# SR/CR A1A PEDESTRIAN SAFETY & MOBILITY STUDY

## PEDESTRIAN / BICYCLE SAFETY REVIEW

Focus Area C / International Speedway Boulevard to South of Earl St. and  
North of Oakridge Boulevard to North of University Boulevard (Daytona Beach)

## **Project Title: Focus Area C Pedestrian/Bicycle Safety Field Review**

Figure 17

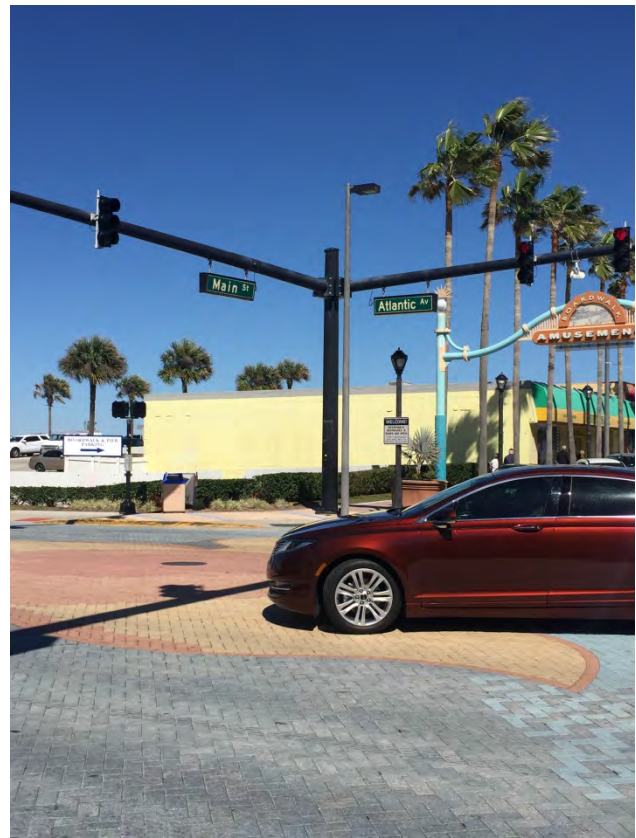
The study review team observed an inconsistency between the street names on push button signage and the existing street name signage. In some cases the push button signage directs pedestrians to cross SR A1A (**Figure 17**), but the existing street name signage present at the intersection states the local street name (Atlantic Avenue – shown in **Figure 18**). The high level of tourists unfamiliar with the state road designation may lead to confusion at the crossings.

## Location: Auditorium Boulevard Intersection

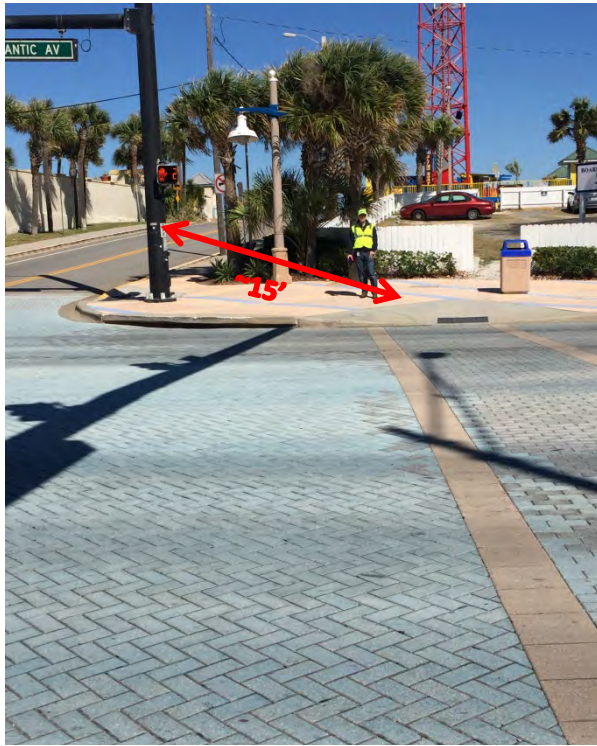
- The pedestrian signal and push button on the southeast corner is not aligned with the south leg crosswalk, located approximately 15 feet from the crosswalk and curb ramp as shown in **Figure 41**. This exceeds the 10' minimum distance to the curb ramp as defined in section 4E.08 of the 2009 MUTCD.
- Pedestrian push button signage is outdated and does not indicate instructions for the pedestrian countdown phase. **Figure 42** also shows that some of the signage has been peeled away on the northwest corner. Part of the signage on the southwest pole has been peeled away also.

**Figure 43**

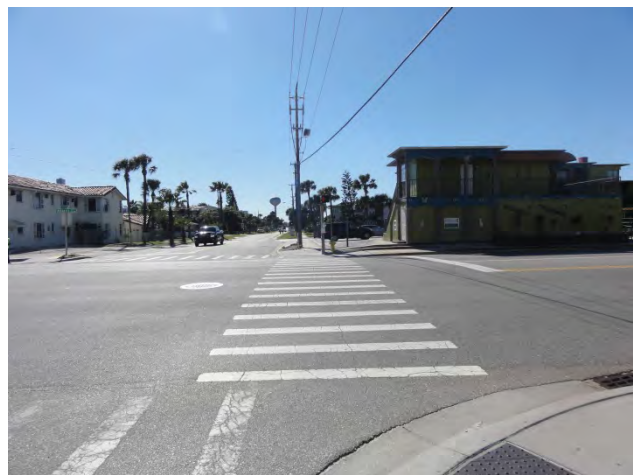
The Hilton driveways just north of the Auditorium Boulevard intersection are long (approximately 100 feet) and do not include a stop bar or crosswalk markings. Vehicles entering or exiting the Hilton are not provided direction as to where to stop or yield to pedestrians. The driveways are shown in **Figure 43**

Consider striping a stop bar on the exiting approach and using standard crosswalk markings across the driveway, consistent with sheet 9 of the FDOT Design Standard Index 17346.

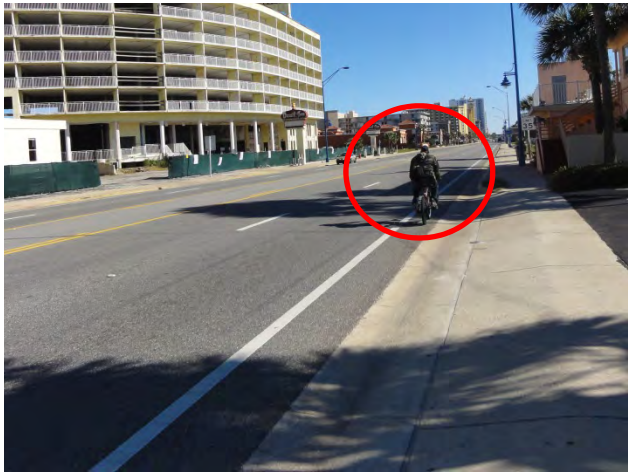
There are inconsistencies between the crosswalk markings at the two signalized intersections within the north section. The signalized intersection of Seabreeze Boulevard and the unsignalized intersections of Glenview Boulevard and Riverview Boulevard have the decorative paver patterns (**Figure 44** and **Figure 45**) described in **Issue #1**. As described earlier, the decorative pavers in the intersection make the marked crosswalks less distinguishable to drivers and do not provide retro-reflectivity at night (see **Figure 46**).

The City's streetscape project ends immediately north of Riverview Boulevard, so the decorative pavers are not included at the signalized intersection of University Boulevard. However, it was noted the marked crosswalks at University Boulevard are old special emphasis markings that are beginning to fade. This is illustrated in **Figure 47**.

Consider removing decorative pavers within the crosswalk and installing material that thermoplastic crosswalk markings will properly adhere to. At the signalized intersection of SR A1A and University Boulevard, consider marking special emphasis crosswalk markings as shown on sheet 9 of Design Index 17346. Consider striping special emphasis crosswalk markings consistent with sheet 9 of the Design Index 17346 for the unsignalized intersections at Glenview Boulevard and Riverview Boulevard.

Figure 50

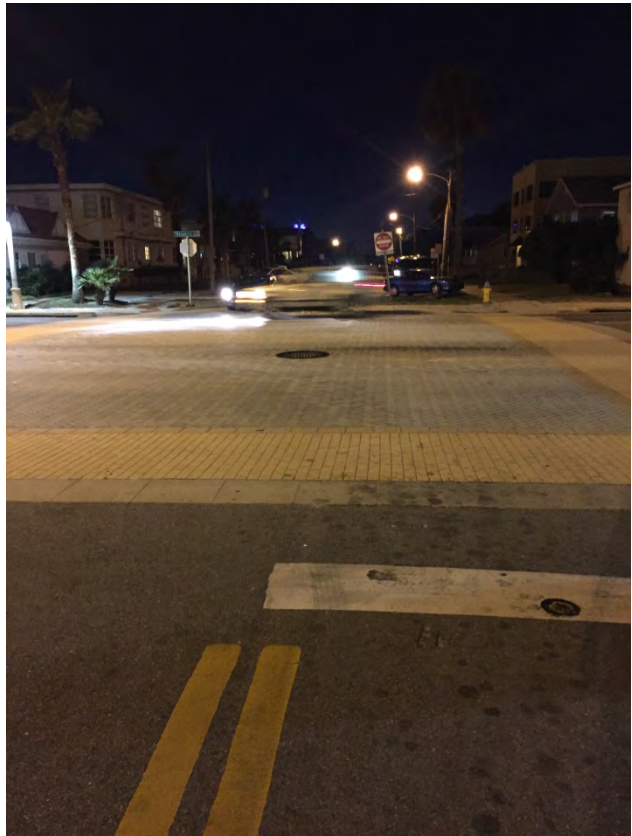
During the nighttime review of the corridors, the review team observed better lighting conditions along the south section due to street lighting, pedestrian-level lighting, and ambient lighting from businesses. There was a noticeable difference between the lighting conditions in the south and north sections. There are fewer businesses in the north section contributing ambient lighting. **Figure 50** and **Figure 51** illustrate the lighting conditions observed by the safety review team during the nighttime review. The field review team noted multiple street lights were burnt out along the corridor. Though pedestrian activity appears to increase along the SR A1A corridor at night, the poor lighting conditions may have contributed to the eight crashes (75% of the corridor's total) occurring at night.

- Replace the lights on the corridor that are burnt out.
- Consider conducting field measurements of existing lighting levels to evaluate lighting uniformity levels and add lighting where necessary. Consider light poles on the east side that are angled westerly away from the beach. These light poles cast their light to the west and illuminate the roadway as needed. The light bulb is not seen by the turtles due to the angle and orientation of the light fixture.

- Consider implementing a lighting plan for the time the sea turtle nesting season is not active as roadway lighting levels should not be reduced at this time.
- Consider implementation of pedestrian-level lighting, with less visibility from the beach, to supplement areas where street lighting is not able to provide adequate illumination.
- As a long-term consideration, upgrade to an adaptive roadway lighting system along the corridor. Lighting levels could be programmed to be reduced during the sea turtle nesting season and increased to normal levels outside of the nesting season. This could be coupled with replacing the current high pressure sodium lighting with LED lighting.
